Technical Note

Project:	P21-390 Land South of Burbage		
Subject:	Land South of Burbage (application ref: 24/00083/HYB) Response to highways comments raised by statutory consultees		
Prepared by:	Jake Blay – Transport Planner	Date:	03/02/2025
Authorised by:	Jo Read – Associate Transport Planner	Status:	S2 - Information
Document Ref:	21390-RLL-24-XX-TN-D-5021	Revision:	P01

- 1.1.3 The comments raised by Leicestershire County Council (LCC), National Highways (NH) and Active Travel England (ATE) are referenced below.
- Leicestershire County Council (LCC) - 2024/0083/04/H/R3 - (01/11/2024) **(Appendix A)**

- National Highways (NH) - NHPR 24-02 - (20/09/2024) **(Appendix B).**
 - Active Travel England (ATE) - ATE/24/00145/HYB – (19/02/2024) **(Appendix C).**

Figure 1: Parking Beat Zone Plan

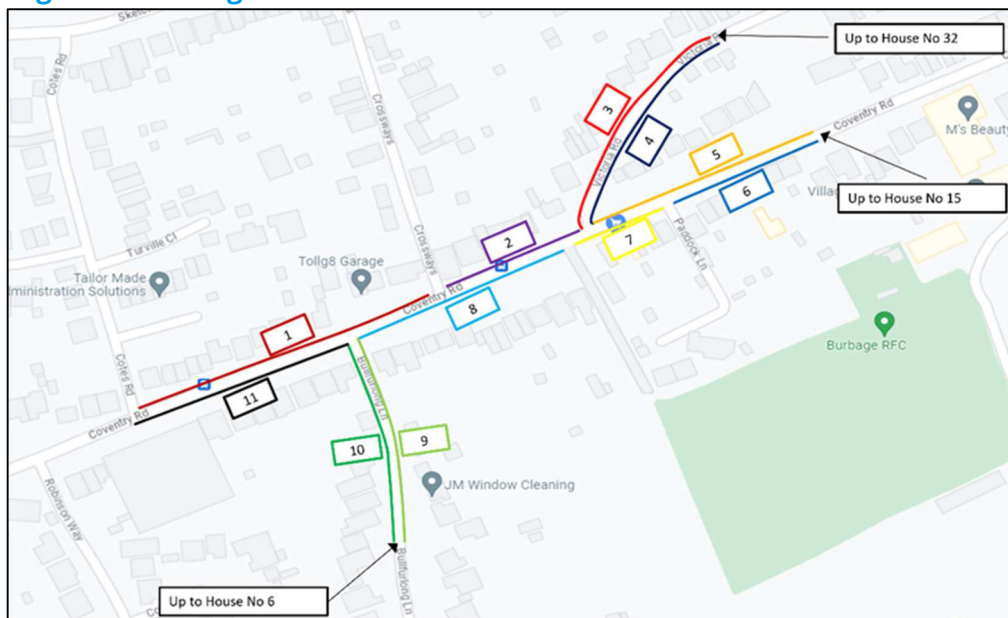
The LHA previously expressed concerns with on-street parking in visibility splays and possible overtaking because of this. The applicant has undertaken a parking survey along Coventry Road on a Thursday, Saturday and Sunday in September 2023 to establish the current position. An overall plan of the study area is included in Appendix J of the UTS but in summary it covers a section of Coventry Road, between 21 Coventry Road and Cotes Road, and approximately 100m of Bullfurlong Lane and Victoria Road.

The study area has been split into 11 zones, and the results of the parking survey indicate that there is sufficient space in the vicinity of the site, including zones 7 and 8 (on the southern side of Coventry Road) even if the TRO is implemented which would restrict parking near the site access to protect the visibility splays. The full results of the parking survey are in Appendix J of the UTA. Notwithstanding the above the applicant has not provided details of which part of the highway each zone has been included therefore, the applicant should provide these details for review and approval. It is also important to note that a TRO is a Legal Order, and this is entirely separate from the planning process; to implement a TRO requires a formal consultation, and as such, there is no guarantee that the proposed restrictions could be implemented.

- 2.2.10 As requested by LCC, **Figure 1** shows the zones for the parking beat survey.

Figure 3: Land South of Burbage Study Area

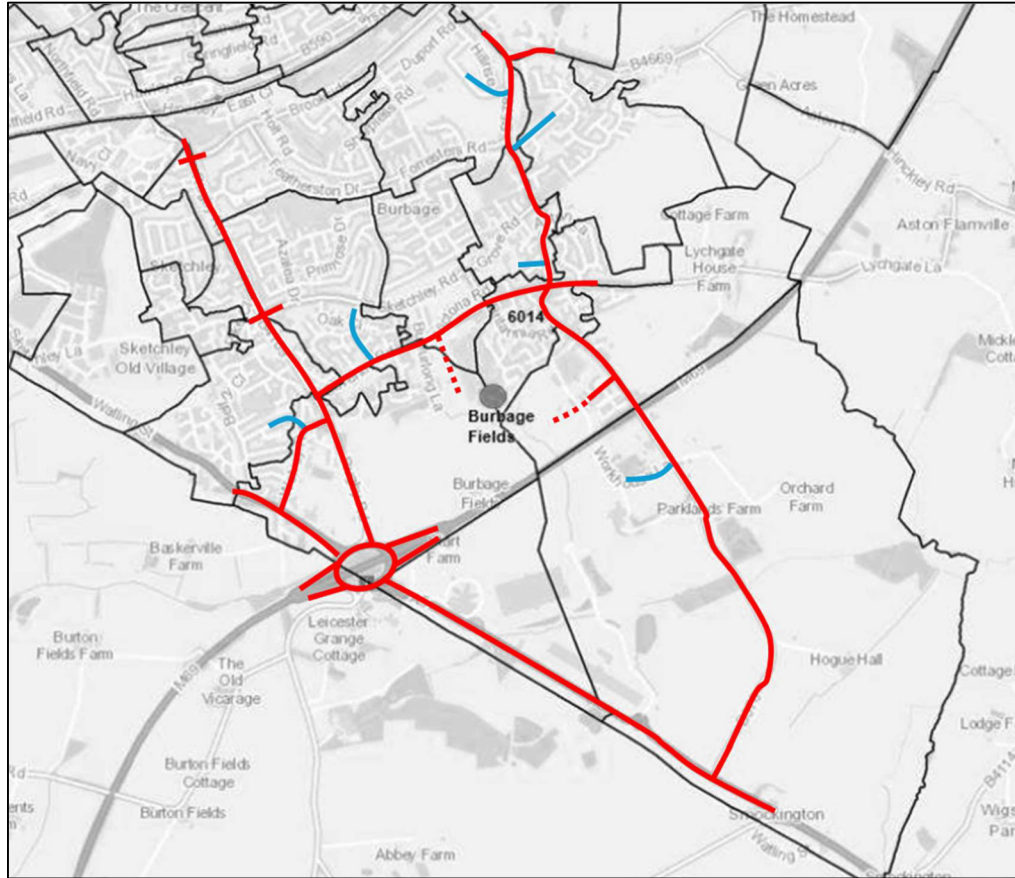
Distribution plots / graphs in Appendix P of the UTA predict that of 46% of development traffic to / from the east of the site and 54% of traffic to / from the Rugby Road area to the west of the site. The LHA is concerned whether the flows / distribution from the Coventry Road site access are correct (as highlighted in National Highways (NH) response). Furthermore, the applicant should confirm that the Coventry Road site access includes any development traffic that might have used the Flanders Close access in the PRTM model runs has been reallocated to Coventry Road.

- 2.5.8 The study area for this exercise was defined by the junctions listed within the *PRTM Burbage Fields, Burbage, Forecasting Report*. A plan of the study area, including the zone plan is shown in **Figure 3**.

Study area annotated in **Red**, locations where trips arrive / depart the study area without using the assessed junctions are annotated in **Blue**. **Dashed Red** lines represent site access locations.

Figure 4: Extract from the select link analysis plots contained within the AECOM Development Trip Distribution Plots report.

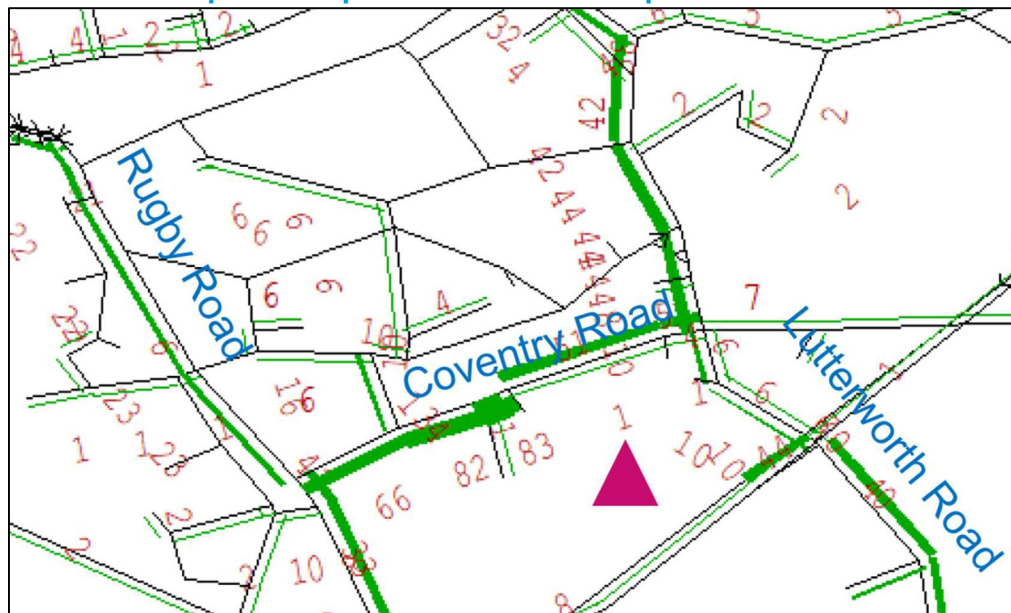
We require further elaboration as to what these plots (AM/PM) represent and their purpose. It is not clear as to whether these distribution plots from PRTM parent zone 6014 are showing how much traffic uses the local network around the development site. We would also appreciate explanation as to what the internal trip numbers represent in these two plots.

- 2.5.11 It was also observed from the select link analysis plots that a proportion of development trips were predicted to arrive/depart the study area between the junctions identified in the *PRTM Burbage Fields, Burbage, Forecasting Report*.
- 2.5.12 As can be seen from the extract from the select link assignment plot shown in **Figure 4**, development trips assigned within the PRTM model have origins / destinations between the junctions forming the study area of the TA. In the example below, for the AM peak hour development trips are travelling to zones to the north of Coventry Road.

- 2.5.13 The comment by NH suggesting that these trips should be *recaptured and presented at Sketchley Road / Rugby Road and Grove Road/B578 for interpretation* is unjustified.
- 2.5.14 As stated by LCC in their response when describing the function of the PRTM, *Whilst for most destinations there are several alternative routes which can be used, the optimal route is selected by the model based on time, journey cost, congestion and delay. This approach is used to better represent real life driver behaviour and choice through the modelling process...*
- 2.5.15 Any adjustment to the calculated trip distribution which was derived from these assignment plots will undermine the use of the distribution taken from the parent zone in the PRTM. It is also realistic to assume that a proportion of vehicle trips would be travelling to / from zones neighbouring the proposed
